GLASTAR SERVICE BULLETIN 5

MANDATORY

Subject: AN470A4-7 soft rivets

Applicability: GlaStar tail and wing kits shipped prior to 10/1/95 with the following kit serial numbers: Tail kits #5002—5116, excluding 5004; Wing kits #5002, 5003, 5005—5008, 5011, 5012, 5014—5019, 5021, 5022, 5024, 5025—5032, 5034—5041, 5043—5045, 5048, 5049, 5051, 5052, 5054, 5055, 5059—5061, 5063, 5064, 5066, 5068, 5069, 5071, 5072, 5075—5077, 5080—5082, 5084, 5085, 5087—5090 and 5104

Figure 1

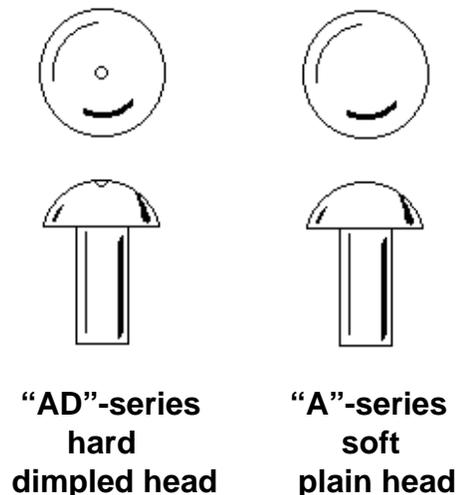
Discussion: It has come to our attention that the supply of AN470AD4-7 universal-head rivets shipped with several GlaStar tail and wing kits was contaminated with some AN470A4-7 rivets. These "A"-series rivets, which were inadvertently mixed in with the "AD"-series rivets by our vendor, are made of a much softer aluminum alloy than the "AD"-series specified for the GlaStar and therefore have insufficient strength. **They should not be used anywhere in GlaStar construction.**

Required Action: First, inspect your supply of AN470AD4-7 rivets and **remove** all the soft, "A"-series rivets. They can be distinguished from the "AD"-series rivets by the heads. As shown in Figure 1, the standard, "AD"-series rivets have a small dimple in the center of the head, while the soft, "A"-series rivets have plain heads.

Second, inspect the GlaStar assemblies specified in Table 1 (if you have completed them) to see if any soft, "A"-series rivets were used. If you discover any soft rivets, you must **drill them out and replace them** with proper AN470AD4-7 rivets. If necessary, refer to "SECTION II: TOOLS AND TECHNIQUES" in the *GlaStar Assembly Manual* to refresh your memory on the proper procedure for replacing defective rivets.
